# Access Compliance Report

## Public Rights-of-Way

Intersection ID: 27777	Main Street: BRIARWICK_LN	Cross Street: MOSS_MILL_LN	Location: NW
ADA ID: 9C6EC0A4F8EA	Ramp Type: PerpDiag	Initial Pass/Fail: Fail	Overall Compliance: No
Severity Score: 25			
Codes/Mitigation Info/Possible Solution		Field Measurements/Component Compliance

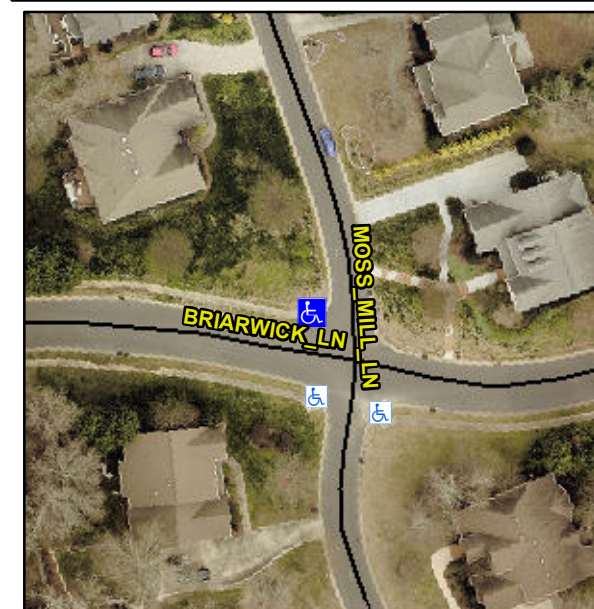
**Not Found, R304.5.3**

Compliance	Description	Data	Compliance	Description	Data
N/A	Ramp Length (in)	96.0	Yes	Ramp Slope (%)	5.4
Yes	Ramp Width (in)	48.0	No	Ramp XSlope (%)	11.2
N/A	Flare Type LT	N/A	N/A	Flare Type RT	N/A
N/A	Flare Slope LT (%)	N/A	N/A	Flare Slope RT (%)	N/A
N/A	Flare Traversable LT?	N/A	N/A	Flare Traversable RT?	N/A
N/A	Landing Length (in)	N/A	N/A	DWS Provided?	N/A
N/A	Landing Width (in)	N/A	N/A	DWS Contrast?	N/A
N/A	Landing Slope (%)	N/A	N/A	DWS Length (in)	N/A
N/A	Landing X Slope (%)	N/A	N/A	DWS Full Width?	N/A
N/A	Landing Curb? (Y/N)	N/A	N/A	DWS Offset (in)	N/A
N/A	Shared Landing?	N/A			
N/A	Gutter Ponding?	N/A	N/A	Gutter Slope (%)	N/A
N/A	Gutter Lip Ht (in)	N/A	N/A	Gutter X Slope (%)	N/A
N/A	Painted X Walk1?	No	N/A	Painted X Walk2?	No
	X Walk 1 Direction	To SW		X Walk 2 Direction	To SE
N/A	X Walk 1 Width (in)	N/A	N/A	X Walk 2 Width (in)	N/A
	X Walk 1 Slope (%)	0.5		X Walk 2 Slope (%)	6.9
	X Walk 1 X Slope (%)	6.5		X Walk 2 X Slope (%)	2.7

**Remove & Replace Curb Ramp With Two New Directional Ramps or Equivalent.**
